# Anti-Coincidence Detector

Tile Detector Assembly (TDA)  
to

Tile Shell Assembly (TSA)  
Mounting Issues –

Report to SLAC on Nov. 18, 2003

# Tile Spacing Issue – Worst Care

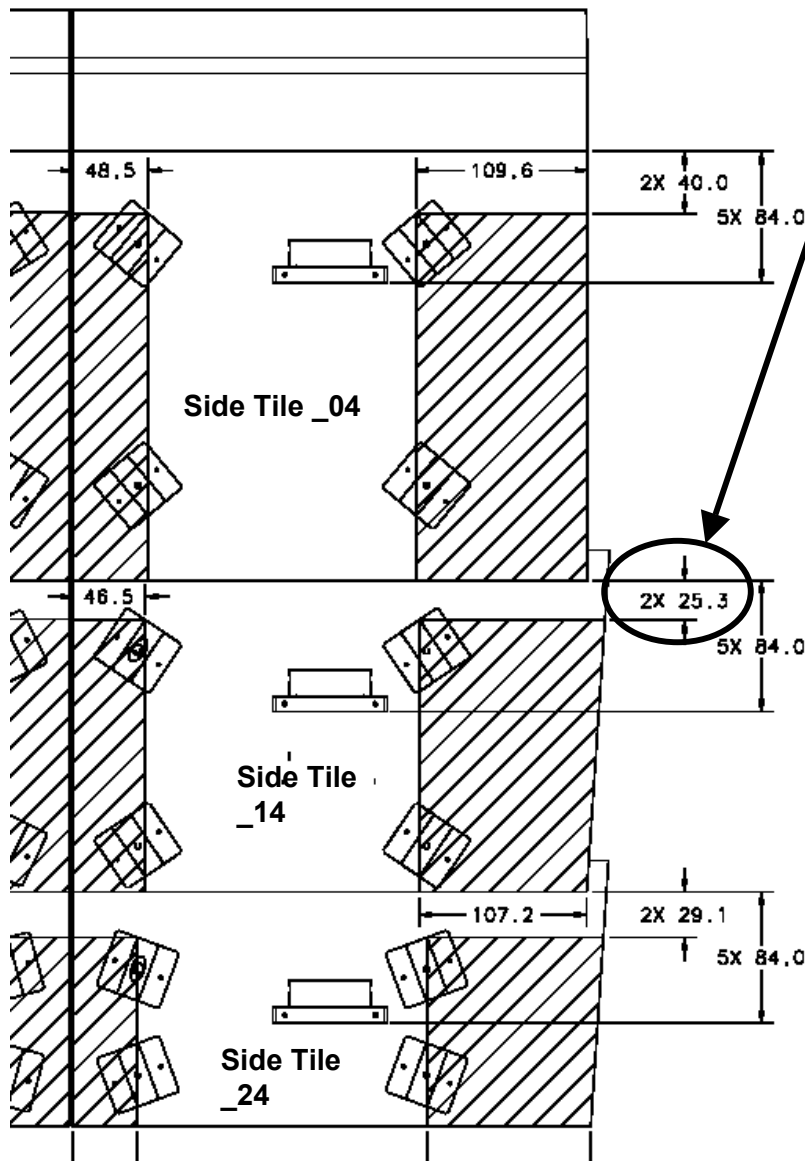
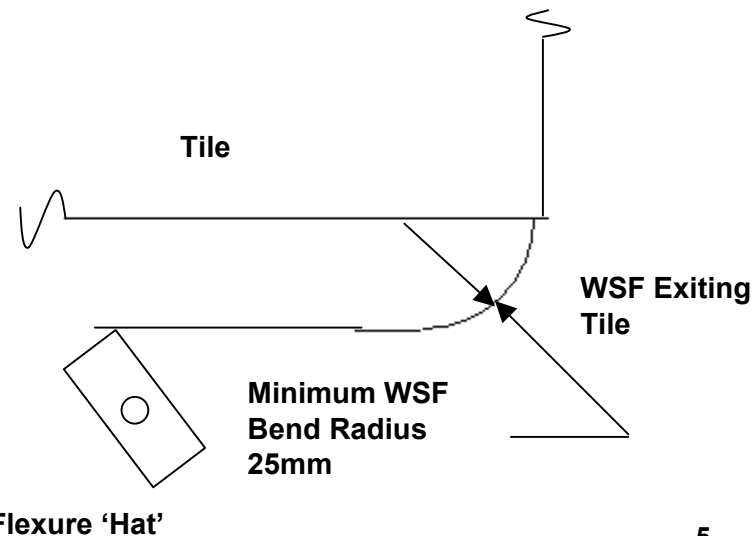
## **BIGGEST CHALLENGE**

•Spacing Between Crown Tile (Row 1) and Row 2 Tile Flexure (Upper) :

•25mm WSF Bend Radius Spacing was the Design at the Time Issue Was Found

•Brings the WSF too Close to Tile Flexures.

# Tile Spacing Issue Solution

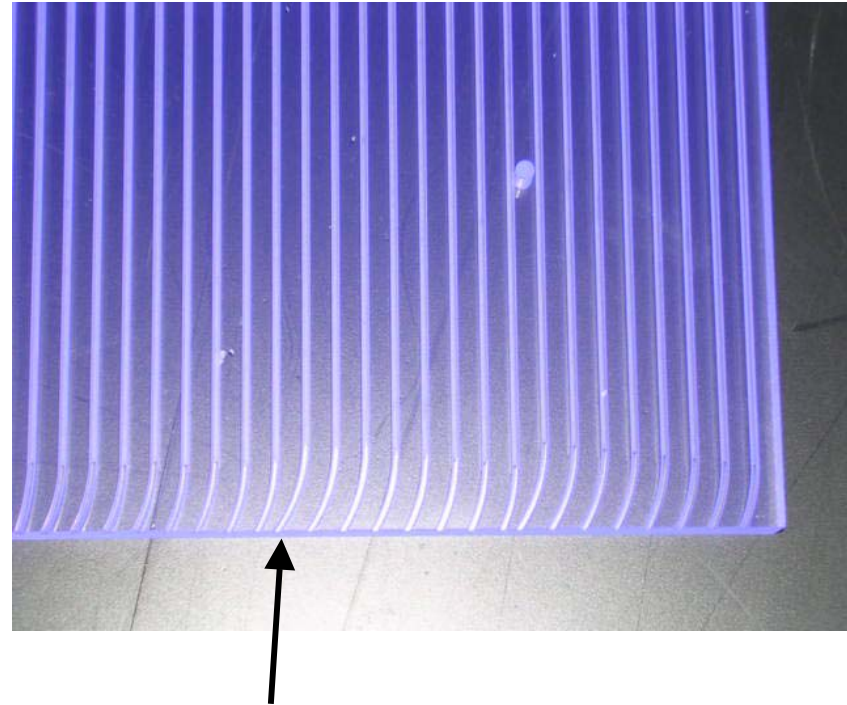
Instead of WSFs Exiting Straight Out Tile Edge (Prior Design), a Groove in the Tile Initiates the WSF Curve 20mm Sooner.

- TDA to TSA MOUNT SPACING
  - *Solutions Implemented*
    - ✓ Establish Design Envelope Between TDAs and TSA Mounts.
      - ✓ Worked With FERMI to Establish Acceptable TDA Envelope
        - ✓ FERMI Changed How the Fibers Exit the Tile
    - ✓ Moved Upper TSA Flexure Mounts 5mm for Row 3 TDAs
      - ✓ Tile Edge to Tile Flexure is Now 30.3mm

# TDA Envelope Drawing

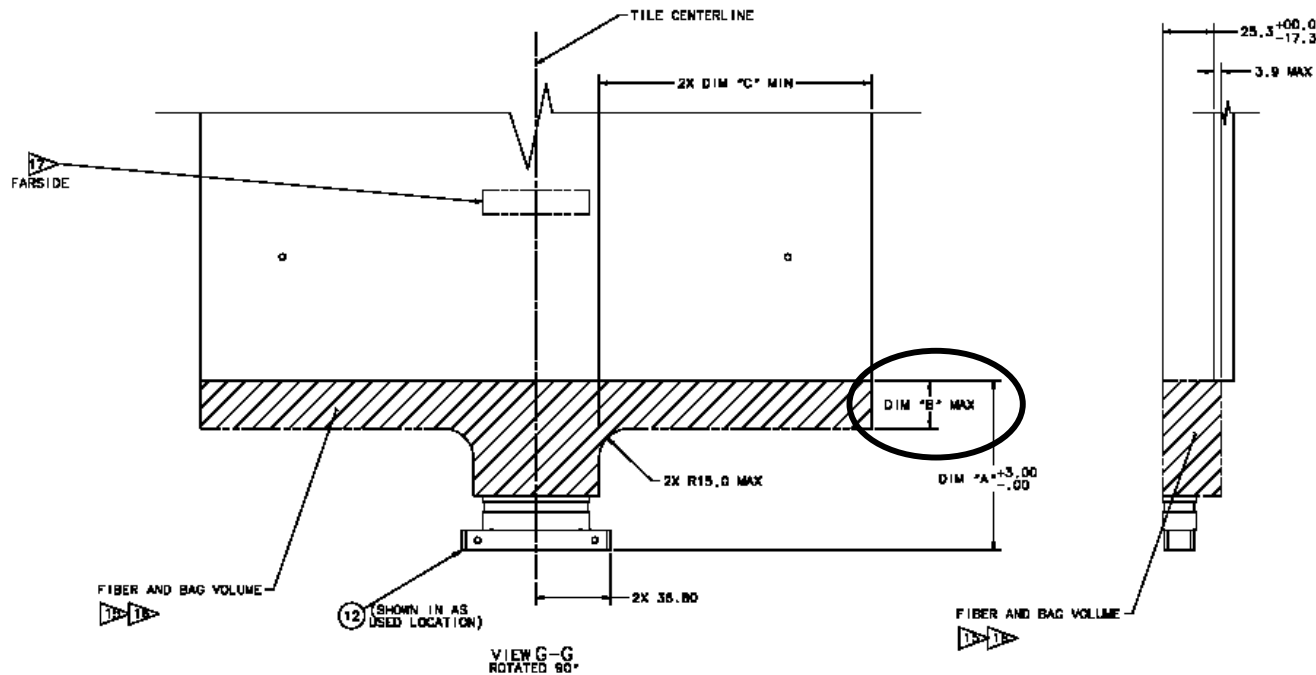
THIS IS SHEET 7 OF EO GD2054511 REV -  
ADD SHEET, TABLE1 AND VIEWS AS FOLLOWS:

- Revised TDA Drawings to Define TDA / WSF Envelope

- Conforms the Numbers (Dim B) FERMI Demonstrated and Agreed with.

- Smallest Tile to WSF Envelope (X-Hatch) Dim 'B' is now 23.7mm (MAX)
- Smallest Tile Edge to Tile Flexure is now 29.1mm
- Minimum of 5.6mm Clearance is now Achieved.

# 3<sup>rd</sup> Row TDA WSF to Bottom Tile Flexure Interference

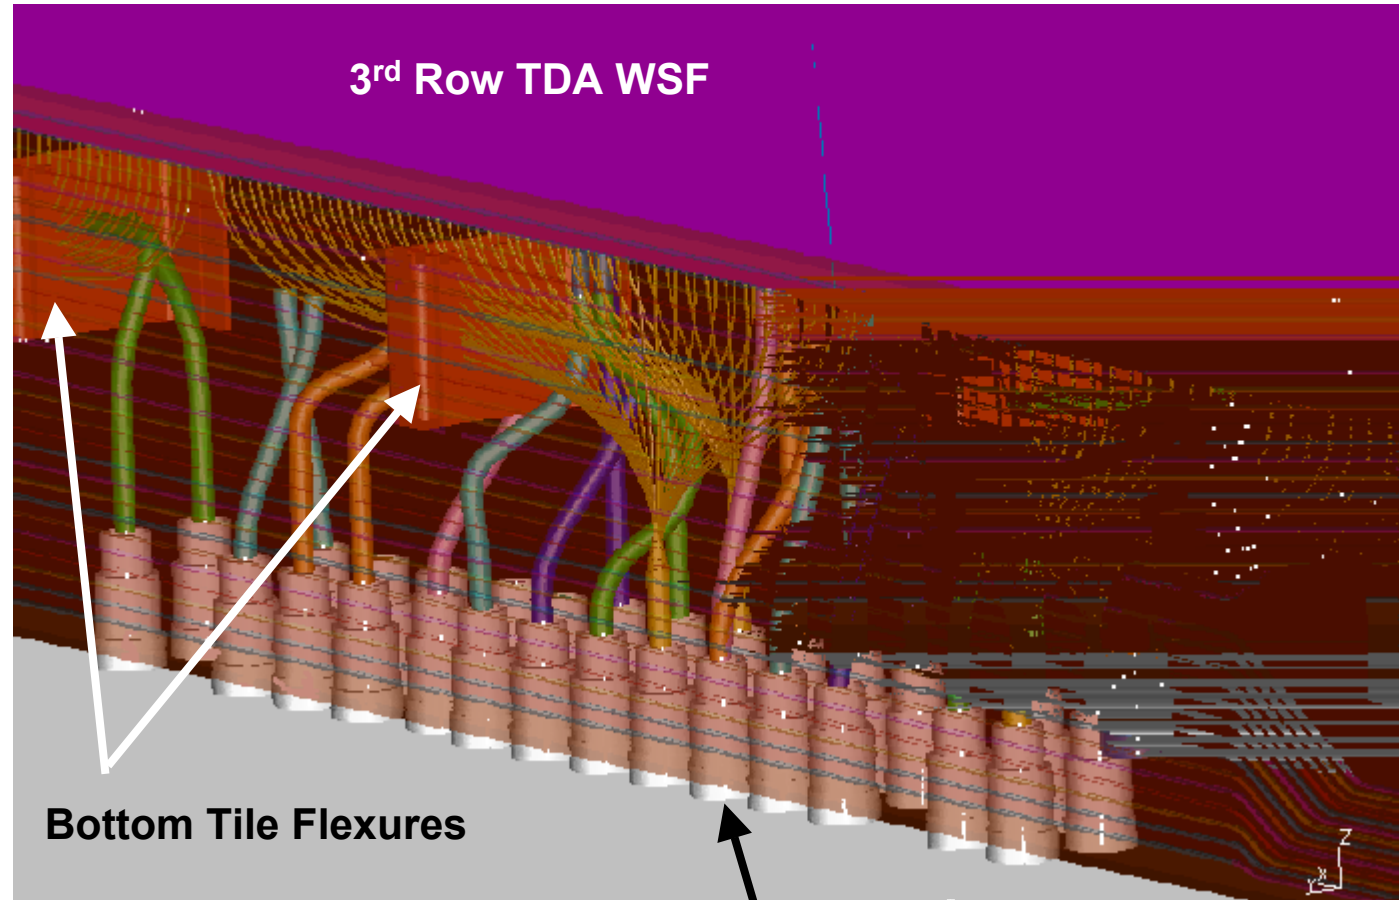
- The Bronze Colored WSF Interfere with the Bottom Tile Flexures Shown

- Note: The WSF terminate directly into the PMTs
